C2M module R_{peak}

D3.1 comment #240

Alexander Rysin and Piers Dawe, NVIDIA

Simulation: COM vs R_{peak} , D3.1 reference model

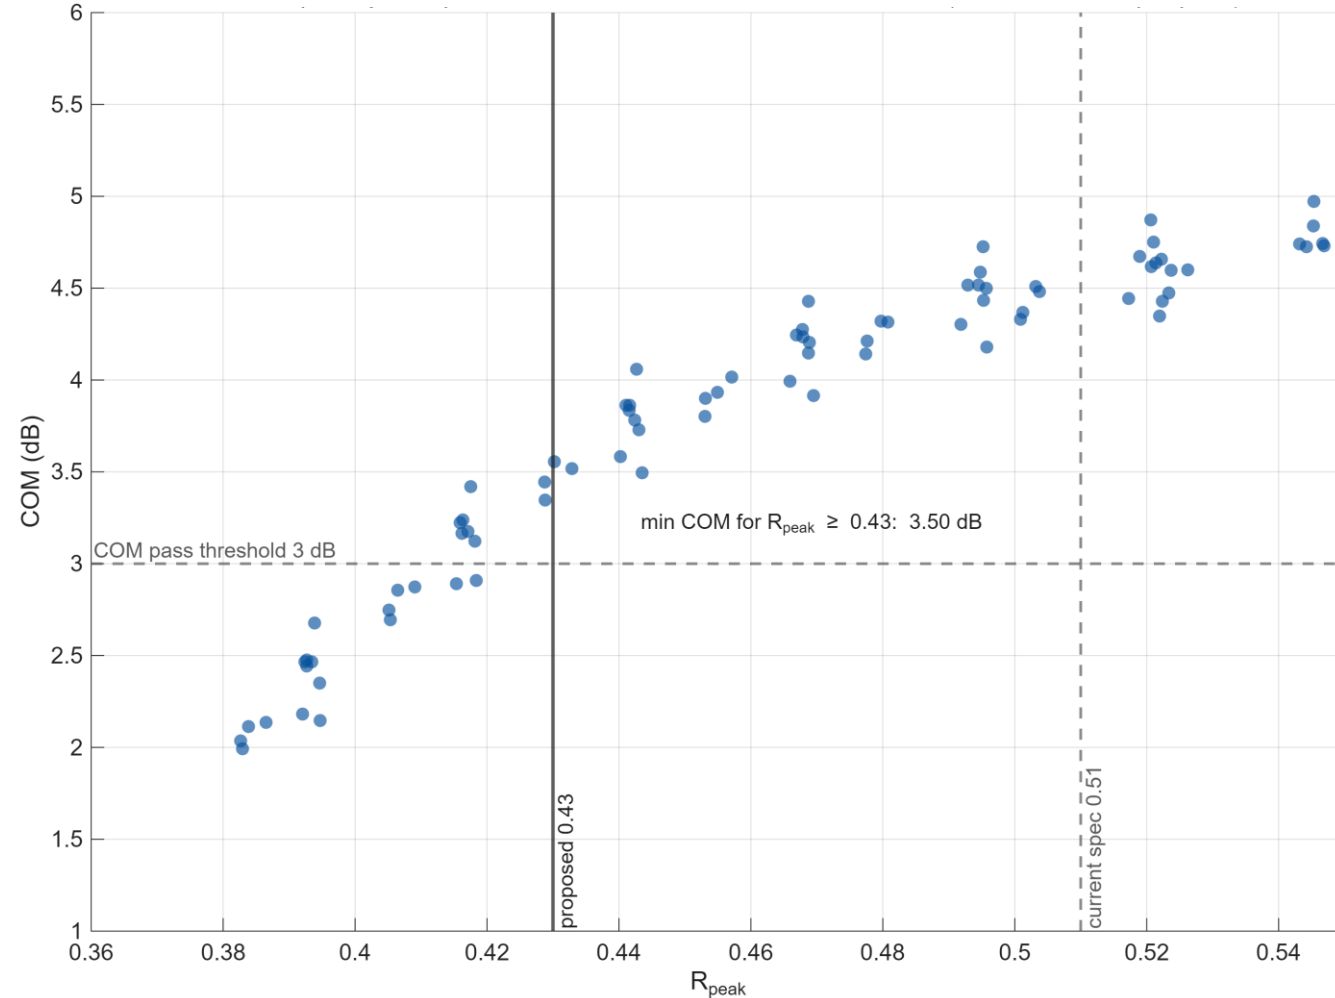
- Numerous mated pair channels
- R_{peak} was altered by TX transition time sweep
- At the reference $T_r = 4$ ps, $R_{\text{peak}} = 0.52$ to 0.55
 - Marginal to the current limit
- Min COM at R_{peak} of 0.51 is 4.35 dB
- Min COM at R_{peak} of 0.43 is 3.5 dB
 - well above the 3.0 dB requirement

1. COM was measured for the complete channel, including a module, a mated pair, the partial host channel model and the host device package model.
2. R_{peak} of ~ 0.43 was achieved for T_r of 7 ps.

Same conclusion with a module package (informative)

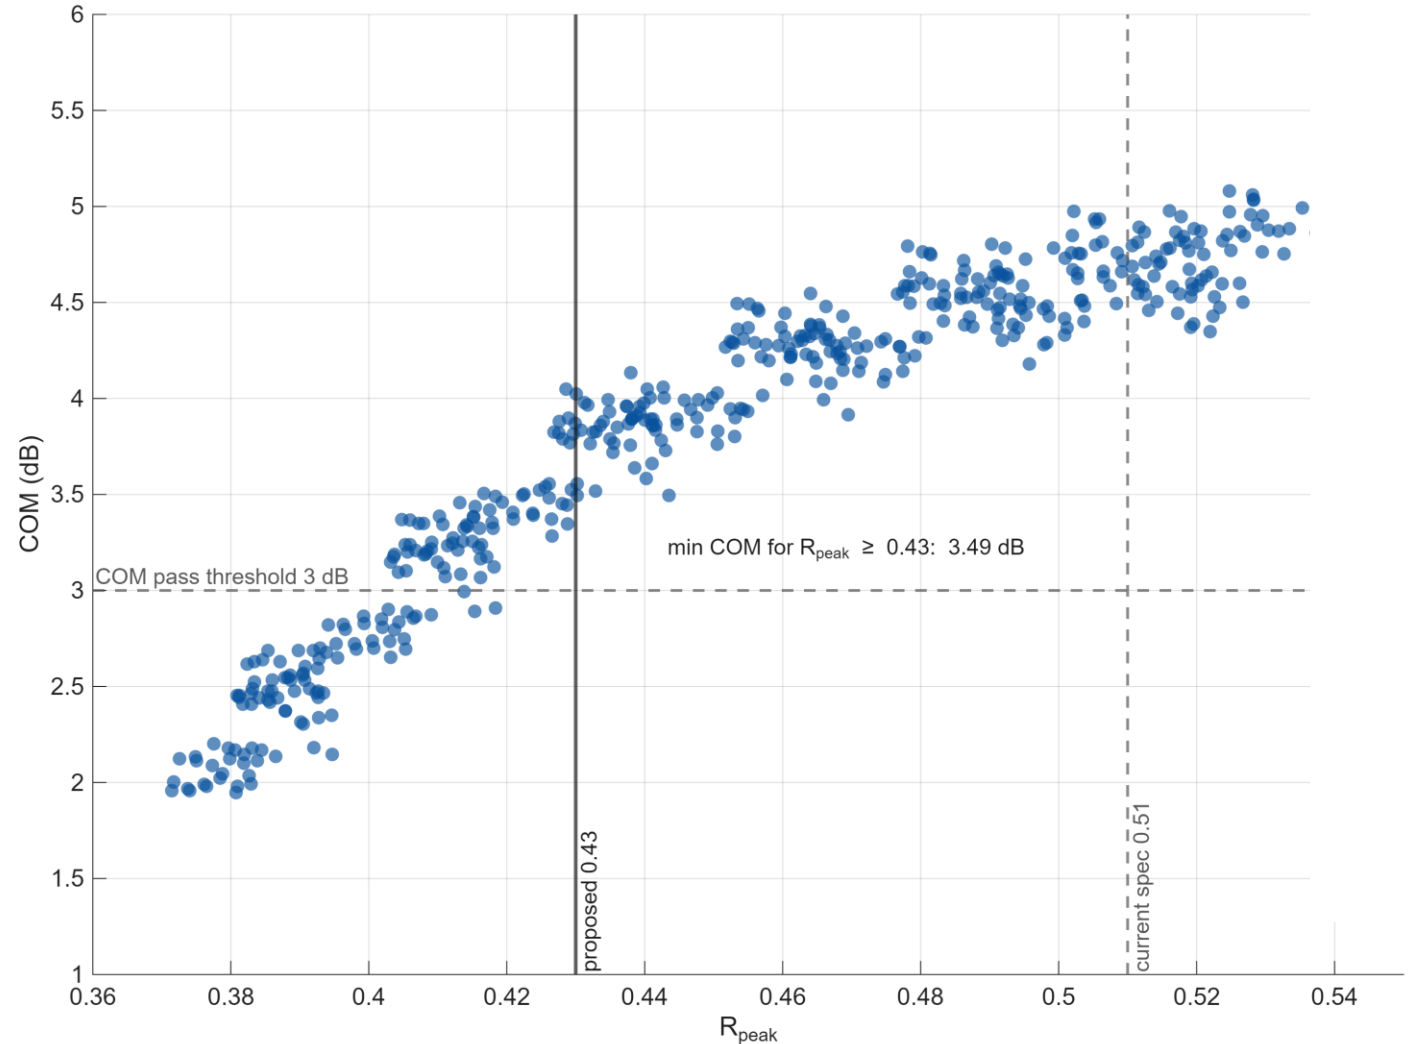
- Same sweep, adding the module device package from the pre-D3.1 draft:
 - informative only: D3.1 removed the module package from the reference model
- COM-vs- R_{peak} relationship is unchanged.

Minimum COM vs. R_{peak} limit

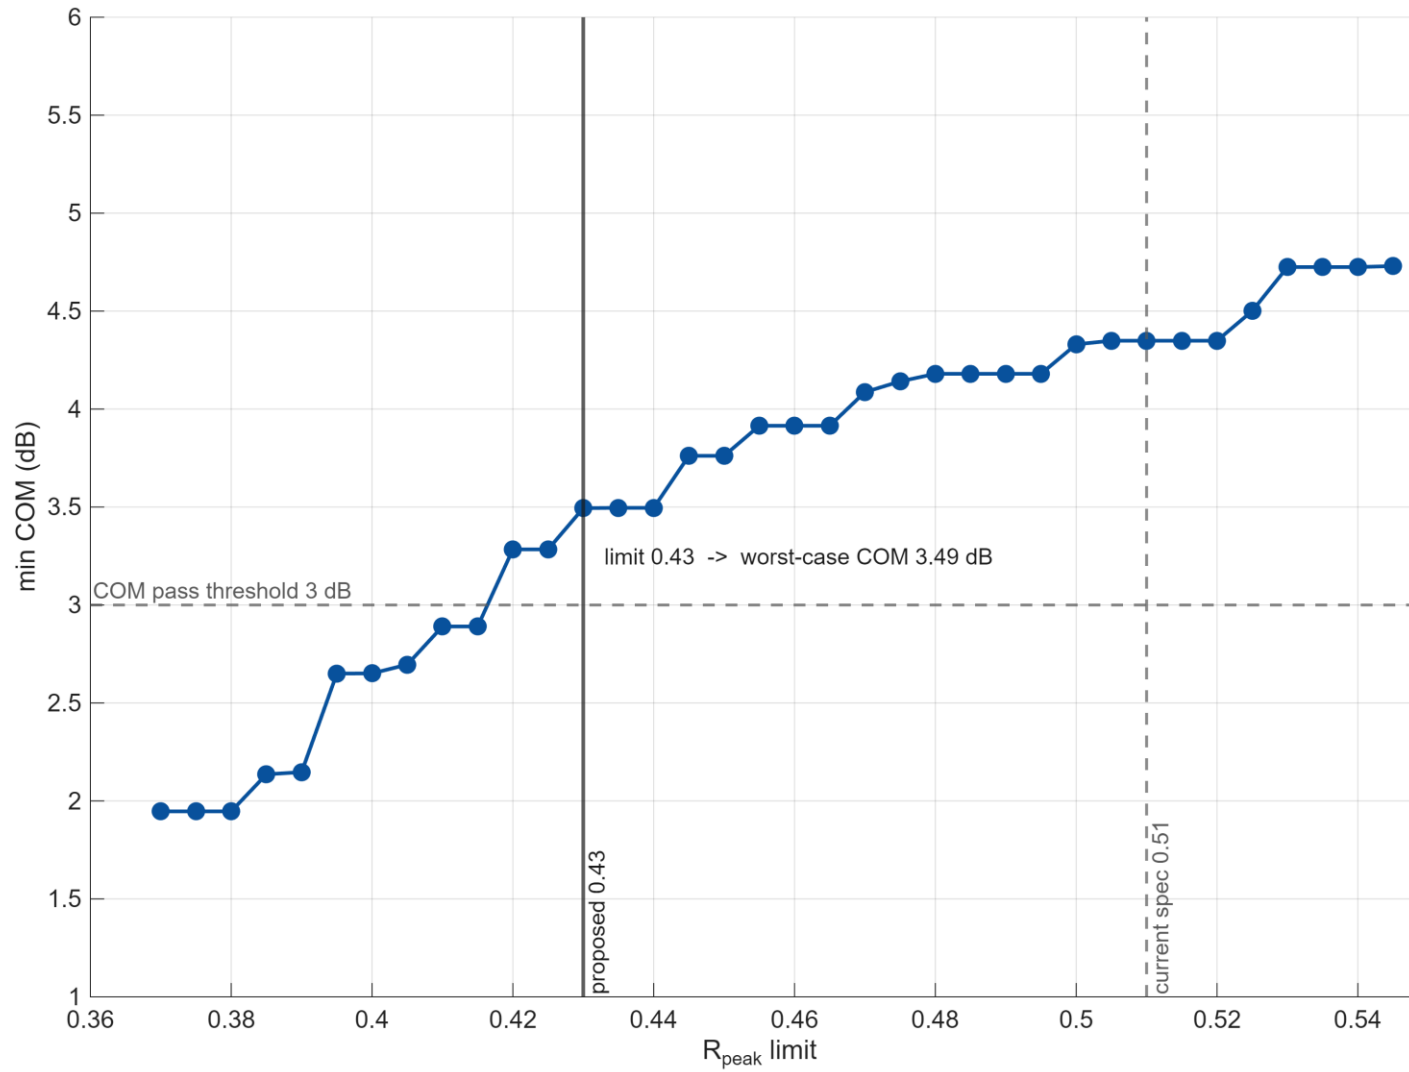
* min COM = worst COM among all simulated points with $R_{\text{peak}} \geq \text{limit}$

- The current R_{peak} limit cannot be met even for slight deviation from the COM reference model.
- Data from recent interoperability events (e.g. calvin_3dj_01a_2601) show that most tested modules cannot meet the R_{peak} and v_f specifications together for the same TX preset. With that, these modules exhibited good interoperability with compliant hosts.
- R_{peak} limit of 0.43 will ensure compliance of modules that proved proper interoperability without compromising the link quality.
- Suggested remedy – change the module output R_{peak} limit (Table 176D-3) to 0.43.
